POLICY REPORT  
DEVELOPMENT AND BUILDING

Report Date: June 24, 2011  
Contact: Kent Munro/  
Alison Higginson  
Contact No.: 604.873.7135/  
604.873.7727  
RTS No.: 9234  
VanRIMS No.: 08-2000-20  
Meeting Date: June 28, 2011

SUBJECT: CD-1 Rezoning and Heritage Revitalization Agreement at  
7101-7201 Granville Street (Shannon Mews)

Figure 2 - Rezoning Application Site Plan

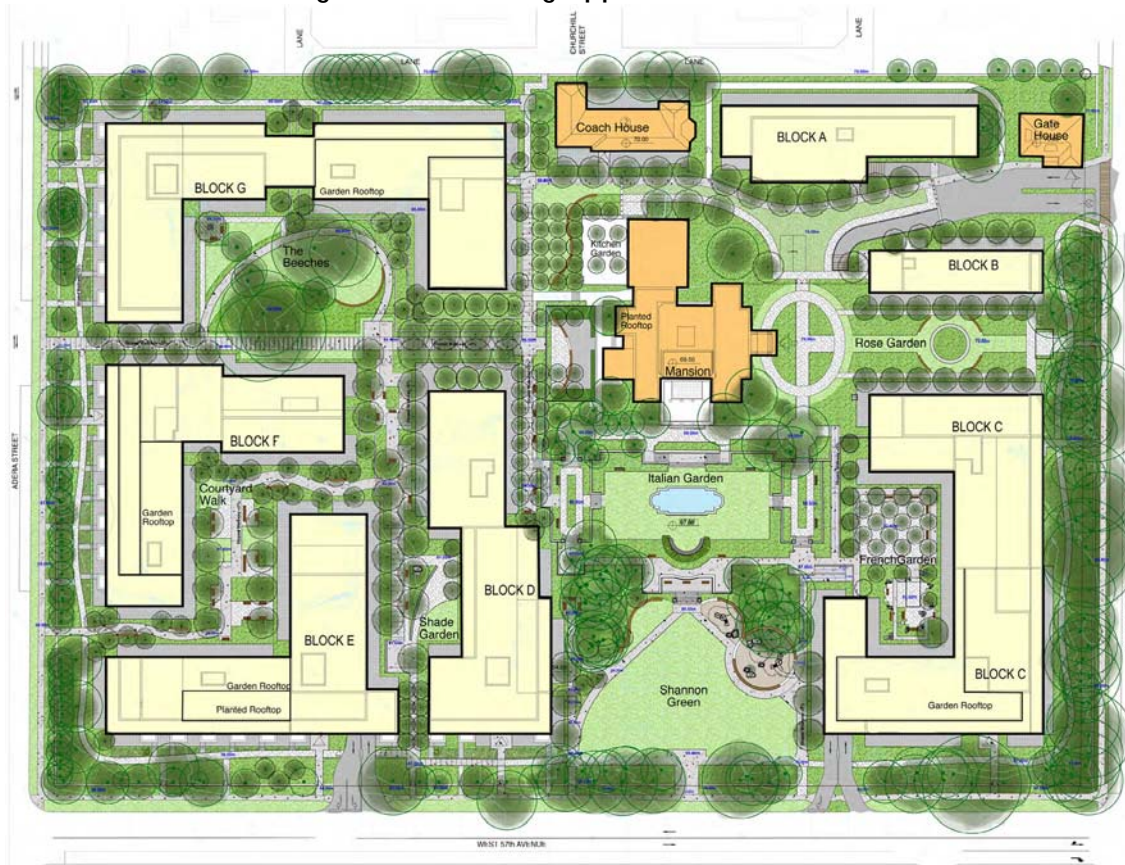
The new garden to the east of the Mansion is an appropriate recasting of the historic Rose Garden and the application proposes an axial view to the Mansion from Granville Street between Blocks B and C. Another view would be provided from Adera Street towards the west elevation of the Mansion, along a walkway that is intended for public access. This pedestrian pathway then widens out to provide a more generous view between Blocks D and G. The most significant view proposed would be from 57th Avenue, across a proposed public park space ("Shannon Green" on Figure 2) towards the south elevation of the Mansion and the Italianate garden. The applicant proposes the removal of the site's perimeter wall at this location. Staff are generally supportive of the above features as illustrated on the rezoning application plans received on May 26, 2011, which will form part of the Council-approved form of development.

Staff have concluded that the creation of well-proportioned outdoor spaces has generally been achieved in proposed plan. The application indicates improvements to the space between new buildings, specifically by providing at least 24 m (79 ft.) of horizontal separation between building faces above the fourth storey. This separation is similar to standards applied in multiple-family environments elsewhere in Vancouver. It is noted that in some areas the current proposal for the site does not achieve this standard, however, the closer spacing in those instances serves to continue the sense of enclosure around the site established by the perimeter wall and trees where the fronts of suites in one building do not look directly into the fronts of other buildings. Some design development is recommended to address this relationship in detail (Appendix B, item (b) 3).

Figure 3: Staff's Recommended Building Heights

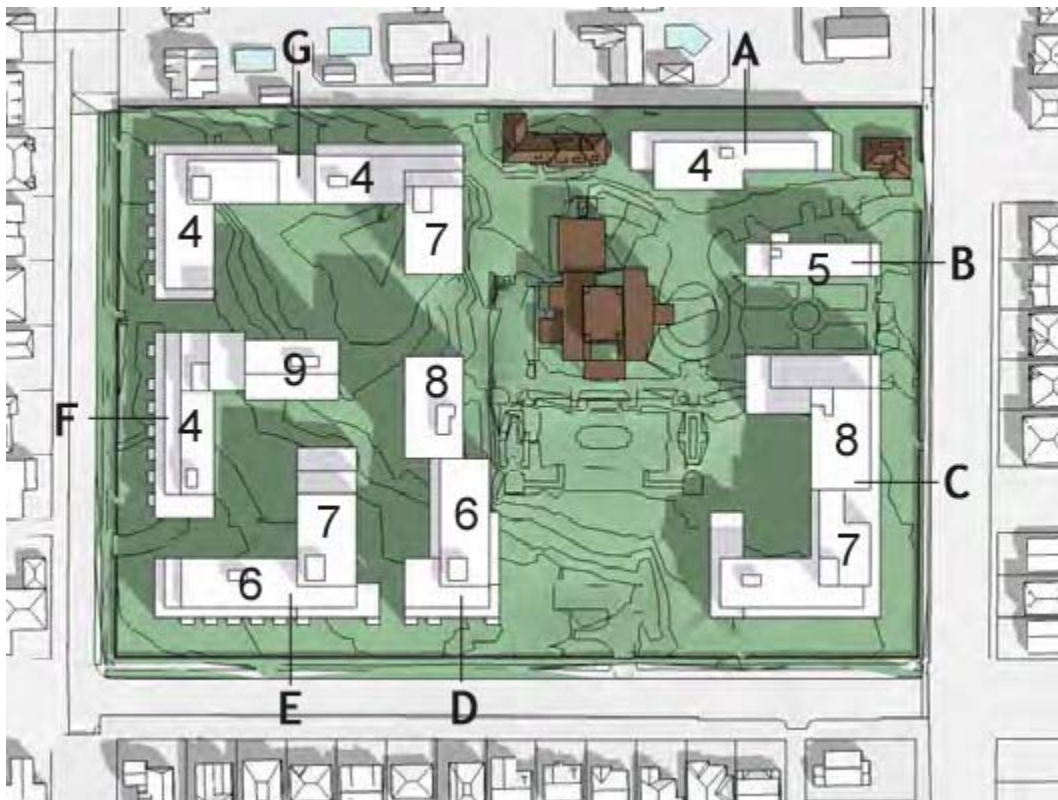
Granville Street intersection, and the on-going neighbourhood concerns expressed through workshops and notification responses, staff are recommending that the highest component of Block C be limited to a maximum of eight storeys, located in the middle of the building on the Granville Street frontage, as illustrated in Figure 3 (Appendix B, item (b) 1.(a)).

The proposed distribution of heights also creates a challenge to the historic fabric of the property such as the proximity of new, taller forms next to the Mansion and the reduction in the Rose Garden's dimensions. While staff accepts a new approach to open space on axis with the current Rose Garden, the proximity of tall new buildings immediately west of the Mansion is of concern. While new forms that are somewhat taller than the Mansion can be accommodated on this site given its overall size and resources, the proposed heights and the complexity of the forms are a challenge to the Mansion's visual prominence. Accordingly, staff are recommending a maximum of one building component at eight storeys (north portion of Block D) with a simplified form, with other building components at lower heights in the range of three to seven storeys (Appendix B, item (b) 1(b)).

The best opportunity for taller forms arises at the centre of the west half of the site, separated to some degree from both existing neighbours and the site's heritage resources in all directions. Staff therefore support one building component up to nine-storeys tall in this location (east portion of Block F), and the remaining forms in the range of three to seven storeys stepping down to the site edges (Appendix B, item (b) 21).
